UNITED STATES OF AMERICA  
NUCLEAR REGULATORY COMMISSION

In the Matter of	)	
TEXAS UTILITIES ELECTRIC	)	Docket Nos. 50-445 and
COMPANY, ET AL.	)	50-446
(Comanche Peak Steam Electric	)	(Application for
Station, Units 1 and 2)	)	Operating Licenses)

AFFIDAVIT OF JOHN C. FINNERAN, JR. IN SUPPORT  
OF APPLICANTS' REPLY TO CASE'S ANSWER TO  
APPLICANTS' MOTION FOR SUMMARY DISPOSITION  
REGARDING CONSIDERATION OF FRICTION FORCES

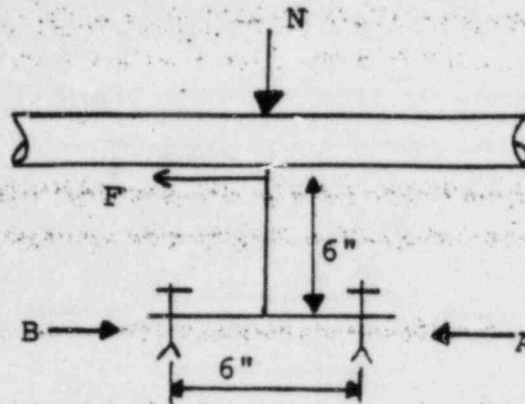
CASE's final claim with respect to this portion of Applicants' motion is that failure to consider friction effects could result in failure of anchor bolts (Affidavit at 9-10). To illustrate its point, CASE uses a hypothetical loading condition which is premised on the same fundamental misconception regarding friction loads which I discussed above with respect to stress ratios. CASE apparently does not understand that a friction load does not act alone. A friction load must act with the normal load from which it results. In CASE's hypothetical the normal load has simply been neglected. Consideration of the normal load for CASE's hypothetical shows that the bolt which CASE claims would pull out cannot even be put in tension. Using CASE's assumed friction force ( $F_f$  of 4900 lbs.), the normal load (N) producing that friction load is easily calculated as 4900 lbs divided by an assumed coefficient of friction (.3), which is 16,333 lbs. Simply summing all moments about

bolt B demonstrates that bolt A cannot even be put in tension, although CASE represented that there will be a 4900 lb. tension load on the bolt. CASE's assertion is, therefore, false.
